# Certificate of Appropriateness

1813 N. 1ST ST.      **Brewers Hill Historic District**

PTS ID 79301 COA, exterior repairs

1813 N. 1<sup>st</sup> St.

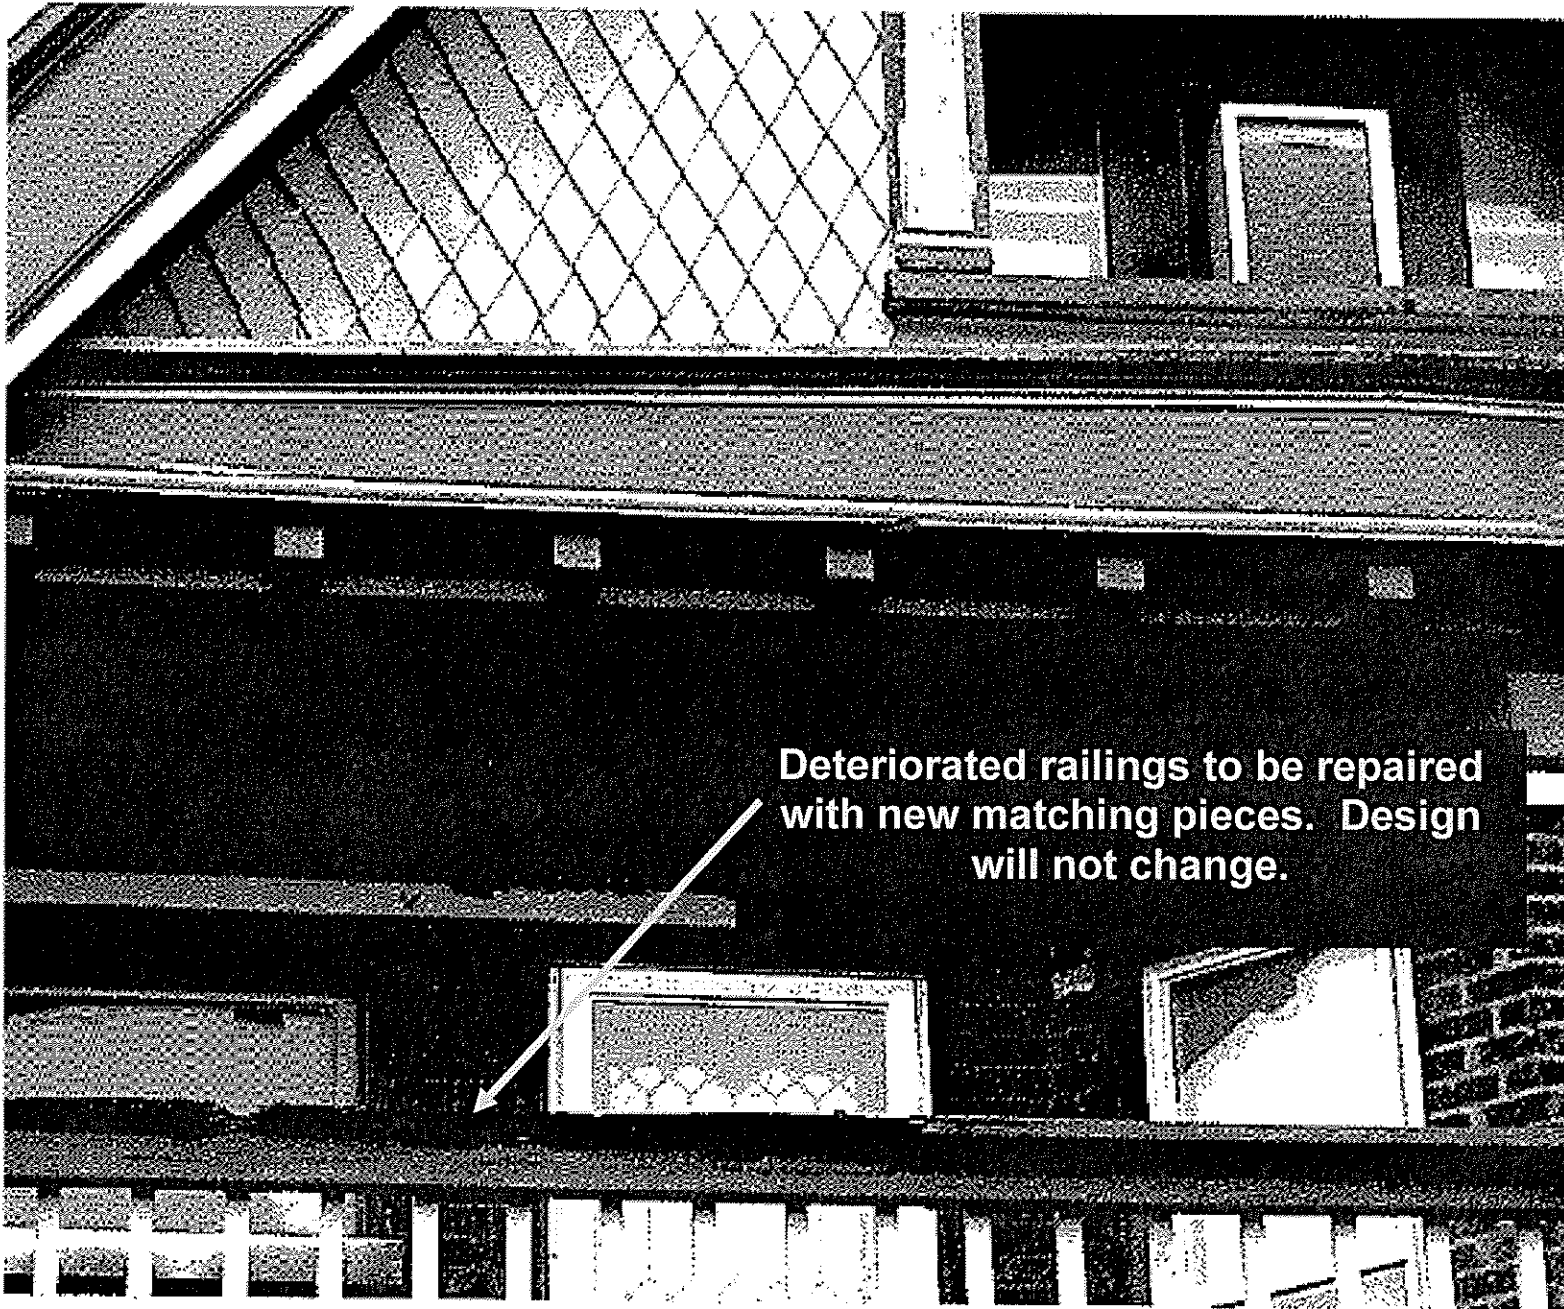
A/C unit to be removed from center window in gable and replaced with a new all-wood window to match the originals. Window will be painted upon completion.
